## STAFF RECOMMENDATION

719 Shelby Avenue

**Application:** New construction-infill and Setback determination

**Description of Project:** Application for infill construction – duplex.

## SITE PLAN

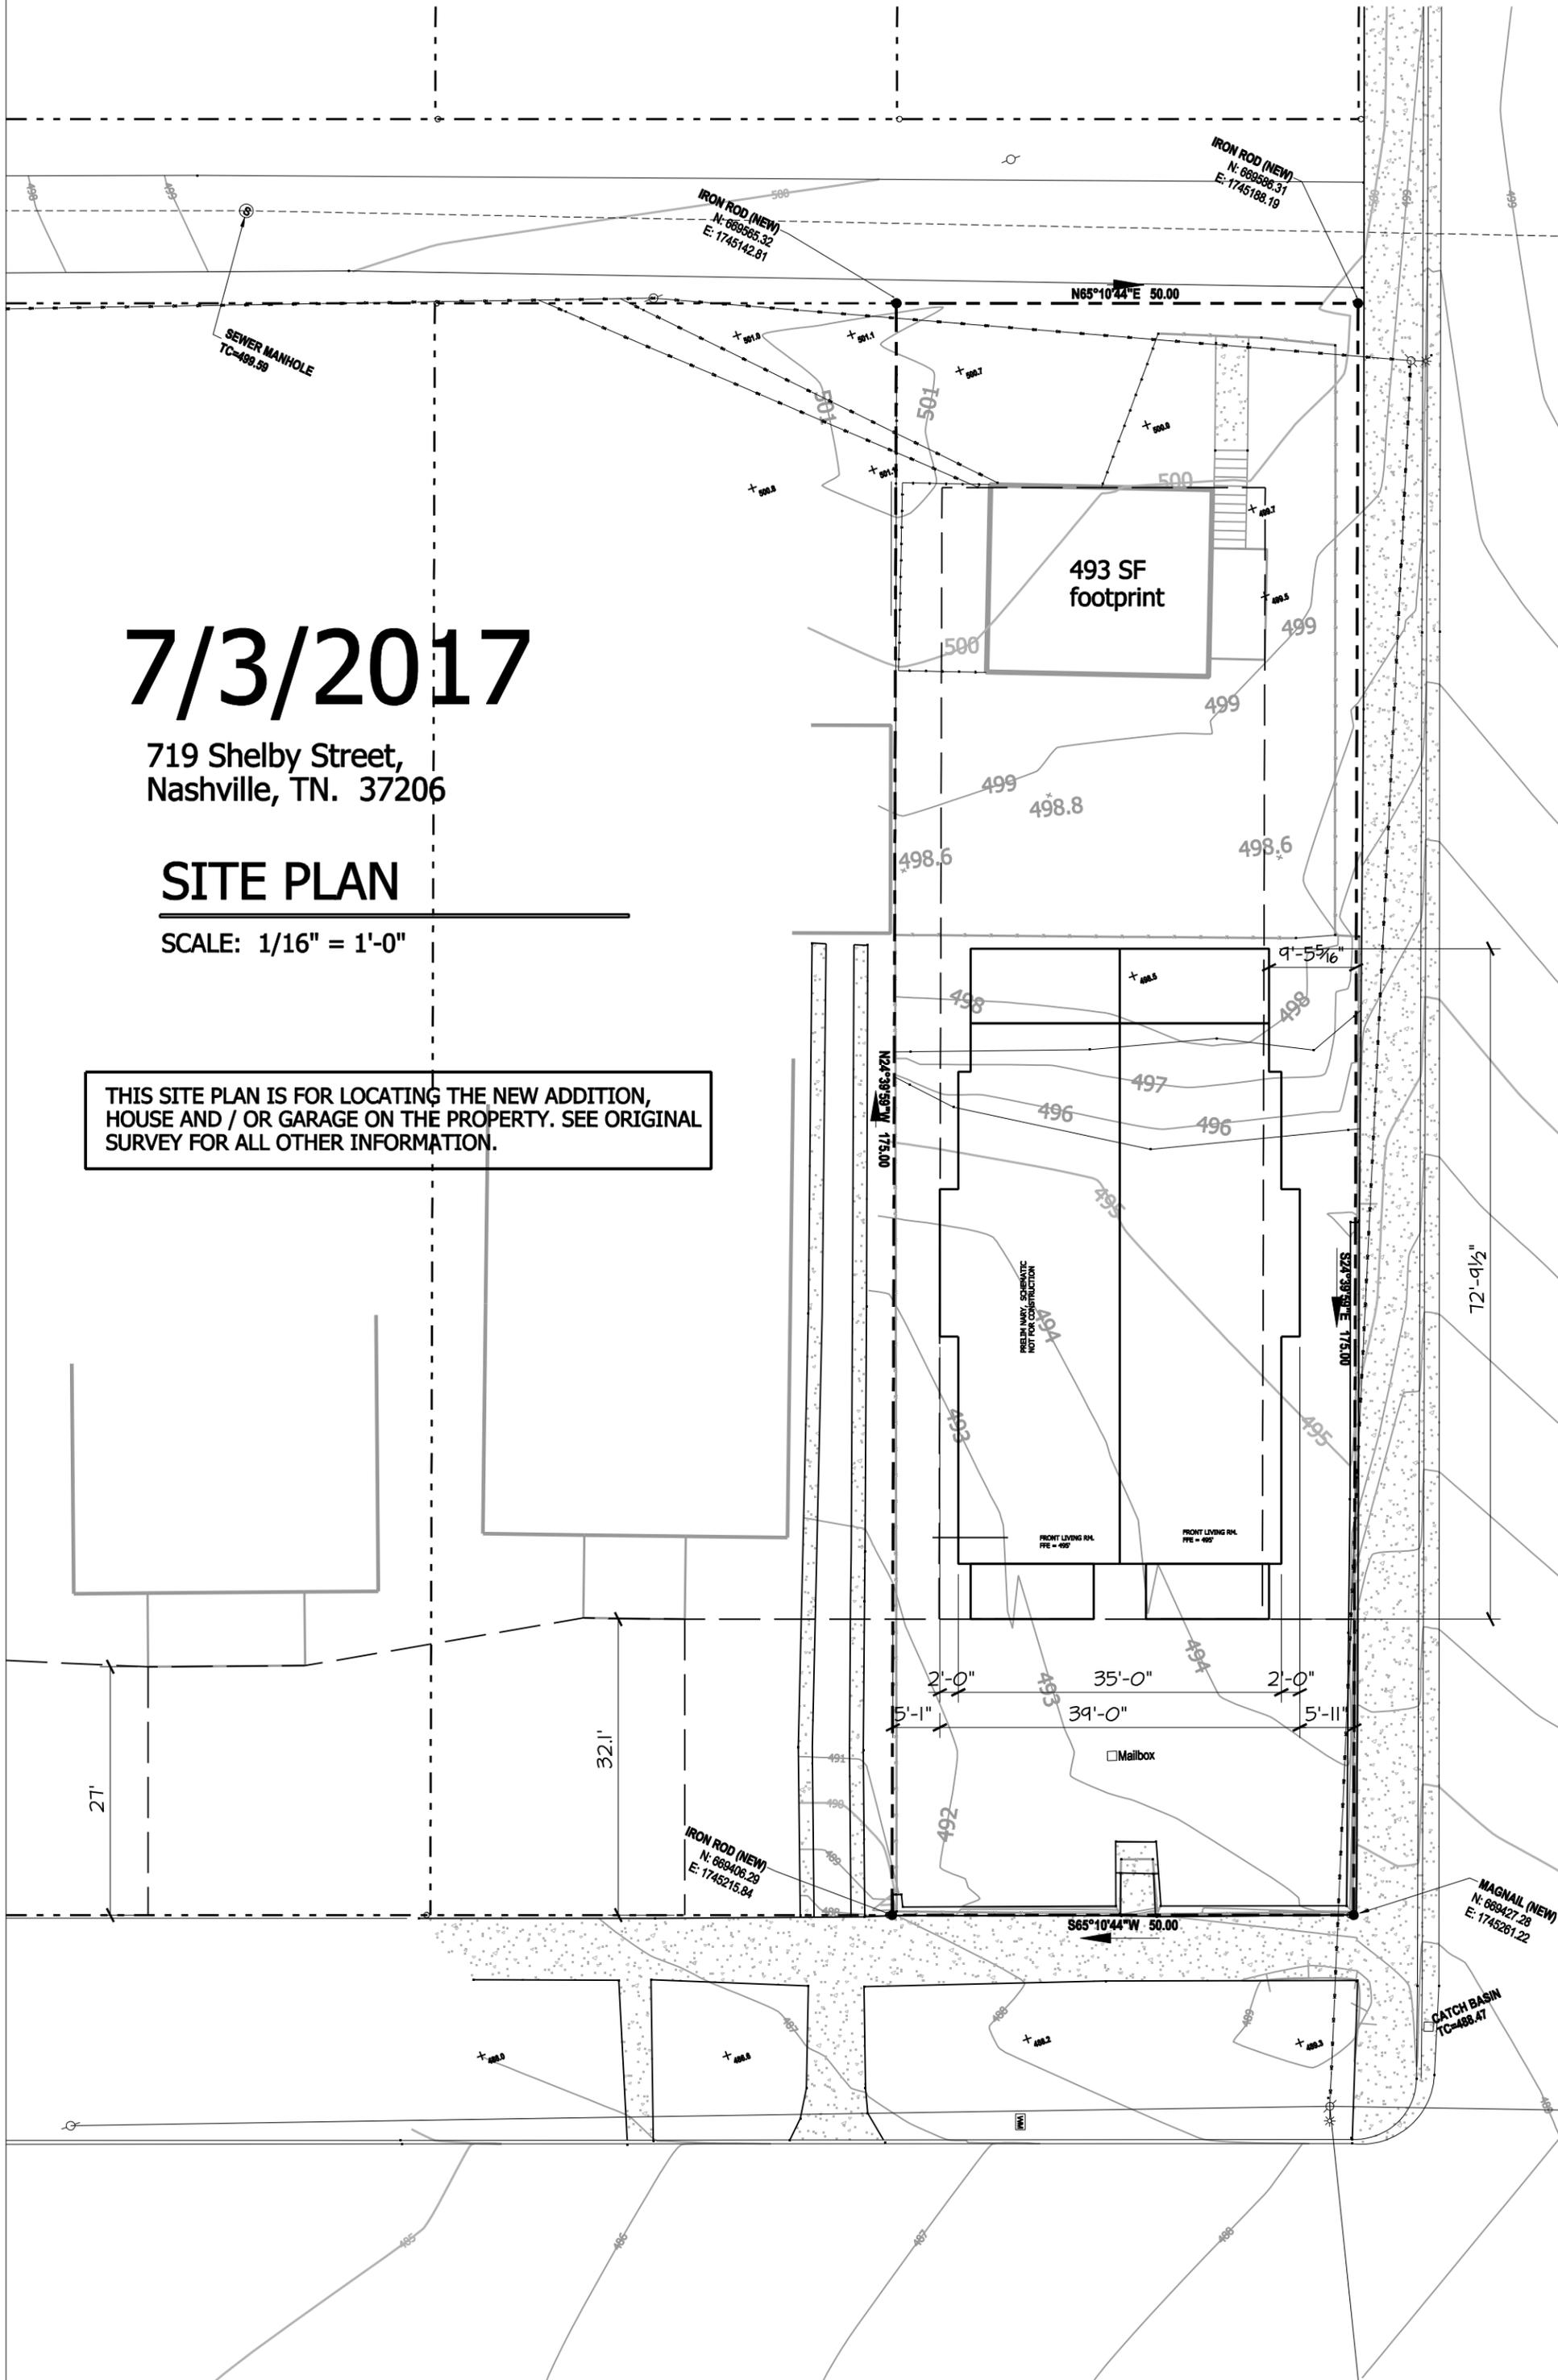
Orientation: The duplex will be oriented so that both front doors face Shelby Avenue, which is appropriate. No walkways have been indicated but should be added to complete the appropriate orientation. Two front porches are provided, at six feet deep (6’) which Staff finds to be appropriate. A rear-yard garage is shown on the site plan but is not a part of the current proposal.

While a new outbuilding is indicated on the site plan, no plans or details have been submitted. The proposed outbuilding will not be reviewed as a part of the current application.

**LEFT SIDE ELEVATION**

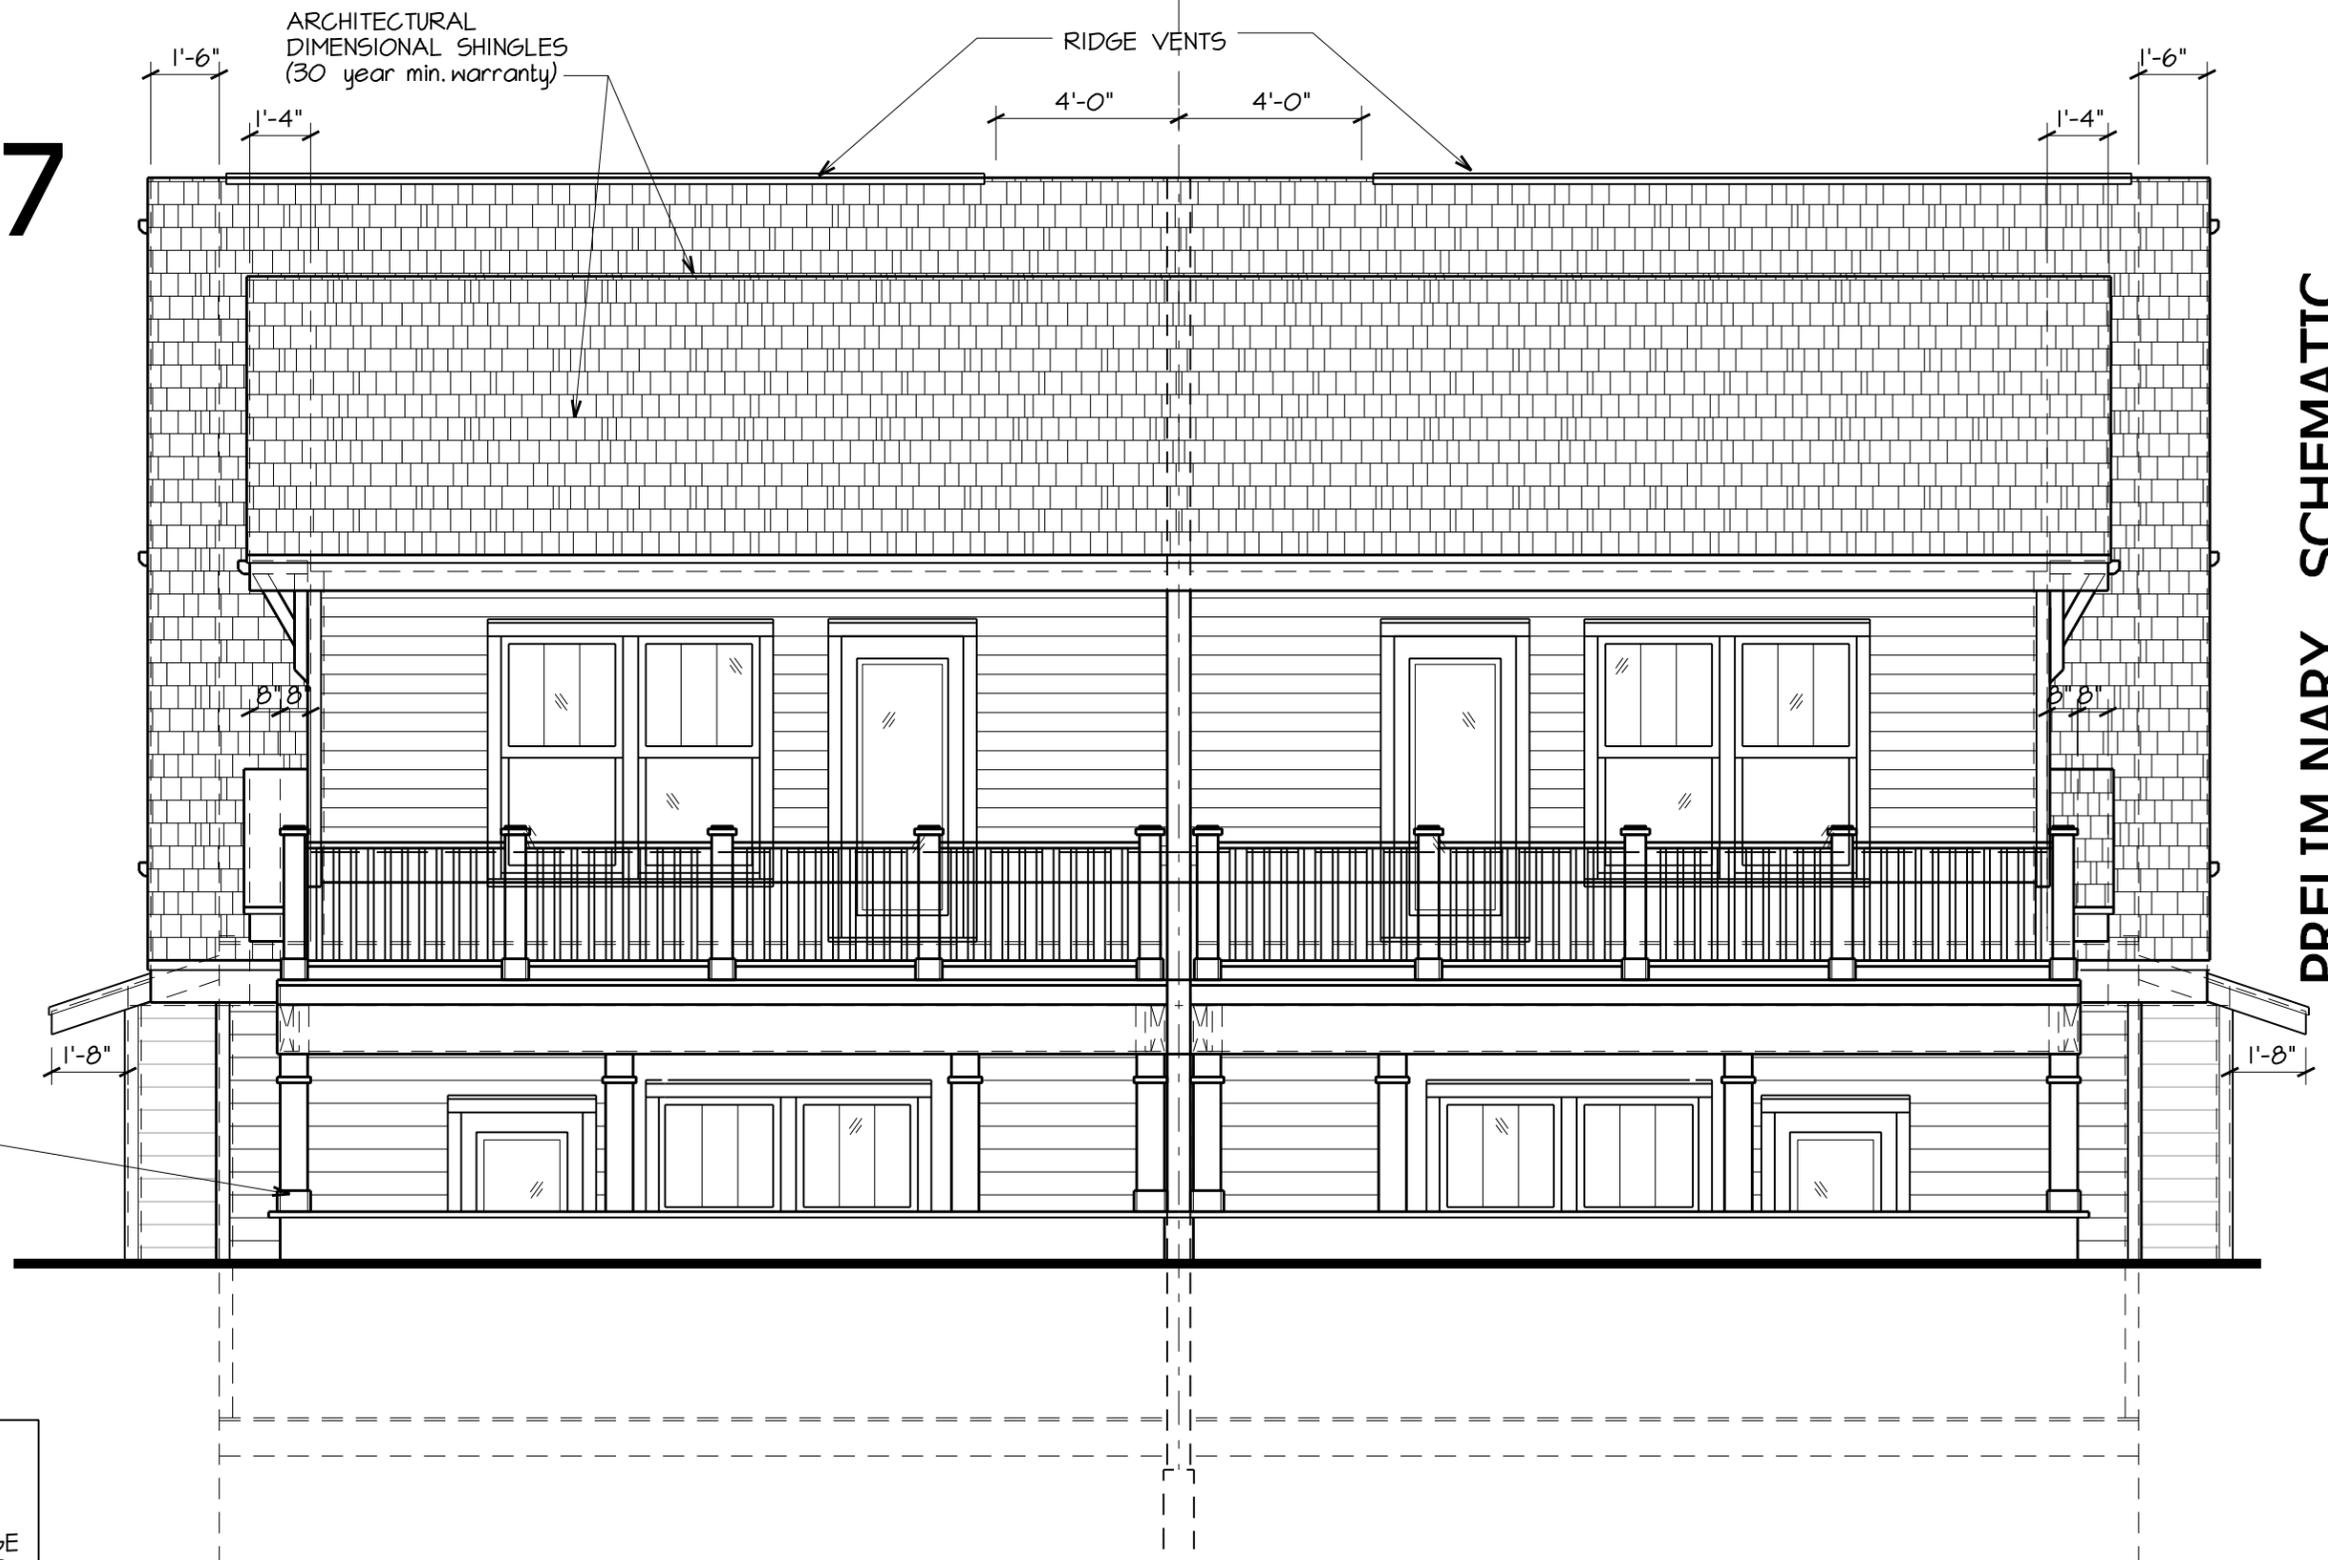
Proportion and Rhythm of Openings: The windows of the proposed duplex are all generally twice as tall as they are wide, thereby meeting the historic proportions of openings. There are several smaller square windows in both the dormers and second level of the building which Staff finds to be appropriate, as these types of windows were seen in these locations historically. Additionally, one long horizontal window is planned

for each side elevation. Staff finds that this type of window is appropriate on these side elevations. There are no large expanses of wall space without a window or door opening. Staff finds the project's proportion and rhythm of openings to meet Section III.B.2.f.
